Summary/Reason Statement for DRH12-00227

Planning Division Staff Report

File Number	DRH12-00227
Applicant	Glenn Levie
Property Address	916 E. Park Boulevard
Public Hearing Date	September 12, 2012
Heard by	Design Review Committee
Analyst	Josh Wilson
Checked By	Sarah Schafer

SITE PLAN

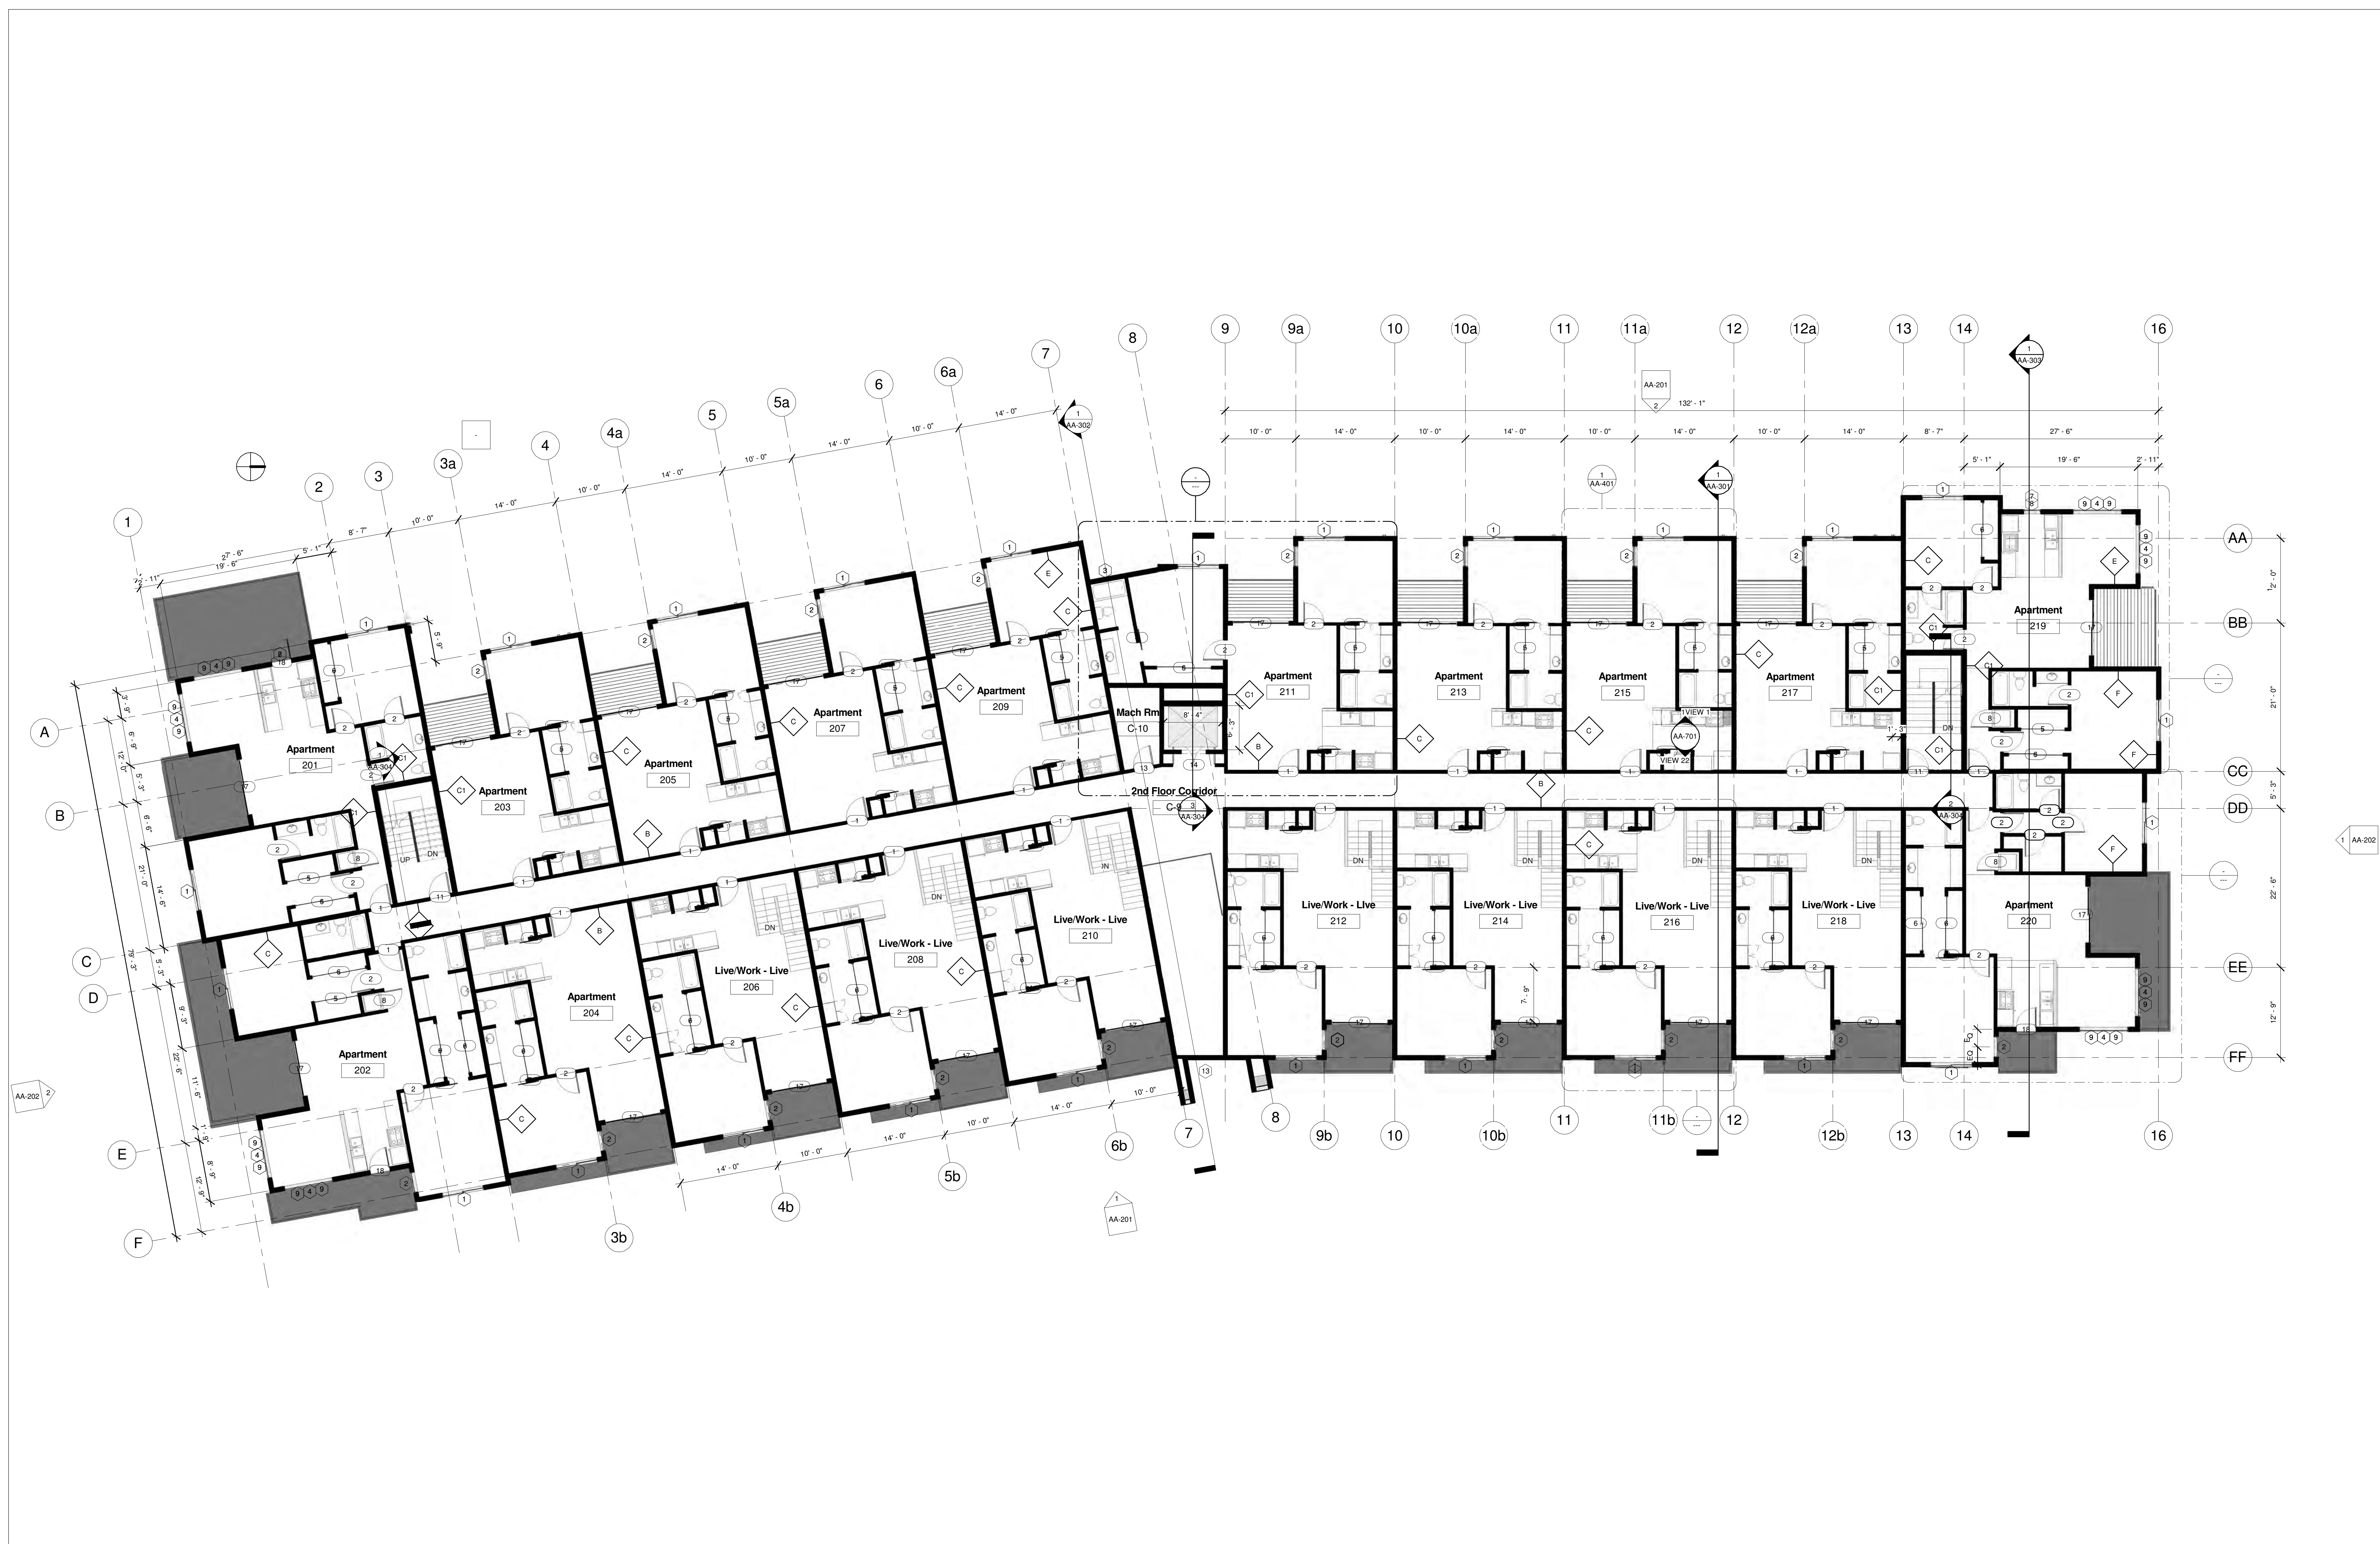
The applicant has proposed to construct a trash enclosure on the northwestern portion of the parking lot which generally complies with the location requirements of Boise City Public Works, which the requirement that it be centered on the drive aisle. The applicant shall comply with the dimensional standards as outlined in the memo dated August 9, 2012 from Peter McCullough, Solid Waste Manager. Mechanical HVAC units will be required to service the proposed building and will be located on the roof and screened by the parapet.

1. The trash enclosure should be centered on the drive aisle to provide the 50' of straight line access required.
